35-TYPE CONVERTER SETS — ADJUSTMENTS

APPARATUS AFFECTED: 35A, 35B, 35D, 35E, 35F, 35G and 35H Converter Sets.

- (1) To simplify adjustment methods and requirements.
- (2) To revise and update wiring diagrams.

8.19 GEAR MECHANISM

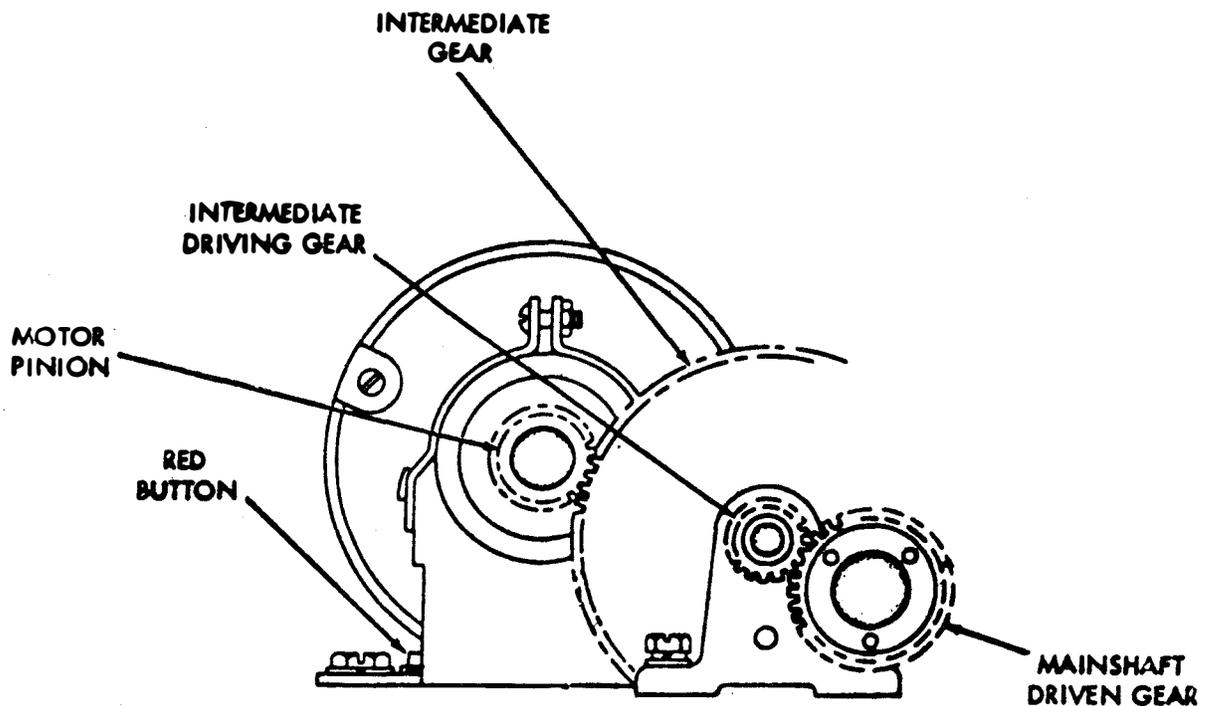
(A) Tape Reader Gear Backlash

The location of subparagraph (A) on page 30 has been changed and will read as subparagraph (B) Tape Reader Gear Backlash.

The requirement (A) Tape Reader Gear Backlash has been changed:

From: "Only a perceptible amount of backlash between main shaft driven gear and intermediate driving gear."

To: "Only a perceptible amount of backlash between main shaft driven gear and intermediate driving gear at point where backlash is least."

(B) Intermediate Shaft

The location of subparagraph (B) on page 30 has been changed and will read as subparagraph (A) Intermediate Shaft.

The requirement of Min. 0.015 inch—Max. 0.020 inch has been deleted.

"To Adjust" of new (A) Intermediate Shaft, has been changed:

From: To Adjust.

Position the intermediate shaft assembly to the forward plate loosened.

To: To Adjust.

Loosen the two intermediate gear bracket screws and position intermediate gear bracket.

The note to subparagraph (B) Intermediate Shaft, has been changed:

From: Note: Intermediate shaft adjustment required only on miniaturized base.

To: Note: In some cases, it may be necessary to loosen the motor mounting screws and position the motor to meet the requirements.

ONLY A PERCEPTIBLE AMOUNT OF BACKLASH BETWEEN THE MOTOR PINION AND INTERMEDIATE GEAR AT POINT WHERE BACKLASH IS LEAST.

LOOSEN THE TWO INTERMEDIATE GEAR BRACKET SCREWS AND POSITION INTERMEDIATE GEAR BRACKET.

NOTE: IN SOME CASES IT MAY BE NECESSARY TO LOOSEN THE MOTOR MOUNTING SCREWS AND POSITION THE MOTOR TO MEET THE REQUIREMENT.

ONLY A PERCEPTIBLE AMOUNT OF BACKLASH BETWEEN MAINSHAFT DRIVEN GEAR AND INTERMEDIATE DRIVING GEAR AT POINT WHERE BACKLASH IS LEAST.

LOOSEN THREE TAPE READER MOUNTING SCREWS AND POSITION TAPE READER.
